Access Compliance Report

Public Rights-of-Way

(Curb Ramps)

Intersection ID: N/A	Main Street: W_W_T_HARRIS_BVLD	Cross Street: N/A	Location: SE
ADA ID: 1D7EE9146860	Ramp Type: Perp	Initial Pass/Fail: Fail	Overall Compliance: No
Severity Score: 1.25			
Codes/Mitigation Info/Possible Solution		Field Measurements/Component Compliance

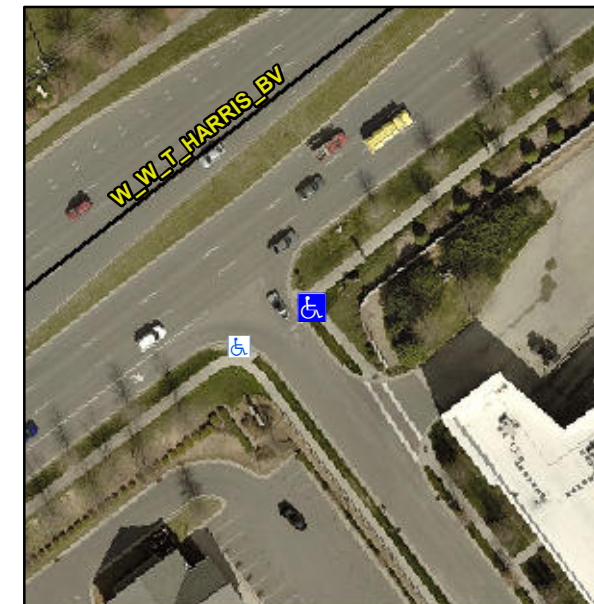
Not Found, R304.5.3

Compliance	Description	Data	Compliance	Description	Data
N/A	Ramp Length (in)	98.0	Yes	Ramp Slope (%)	7.8
Yes	Ramp Width (in)	48.0	No	Ramp XSlope (%)	2.8
N/A	Flare Type LT	N/A	N/A	Flare Type RT	N/A
N/A	Flare Slope LT (%)	N/A	N/A	Flare Slope RT (%)	N/A
N/A	Flare Traversable LT?	No	N/A	Flare Traversable RT?	No
N/A	Landing Length (in)	N/A	N/A	DWS Provided?	N/A
N/A	Landing Width (in)	N/A	N/A	DWS Contrast?	N/A
N/A	Landing Slope (%)	N/A	N/A	DWS Length (in)	N/A
N/A	Landing X Slope (%)	N/A	N/A	DWS Full Width?	N/A
N/A	Landing Curb? (Y/N)	N/A	N/A	DWS Offset (in)	N/A
N/A	Shared Landing?	N/A			
N/A	Gutter Ponding?	N/A	N/A	Gutter Slope (%)	N/A
N/A	Gutter Lip Ht (in)	N/A	N/A	Gutter X Slope (%)	N/A
N/A	Painted X Walk1?	No	N/A	Painted X Walk2?	N/A
	X Walk 1 Direction	To W		X Walk 2 Direction	N/A
N/A	X Walk 1 Width (in)	N/A	N/A	X Walk 2 Width (in)	N/A
	X Walk 1 Slope (%)	7.7		X Walk 2 Slope (%)	N/A
	X Walk 1 X Slope (%)	1.1		X Walk 2 X Slope (%)	N/A

Remove & Replace Entire Ramp.
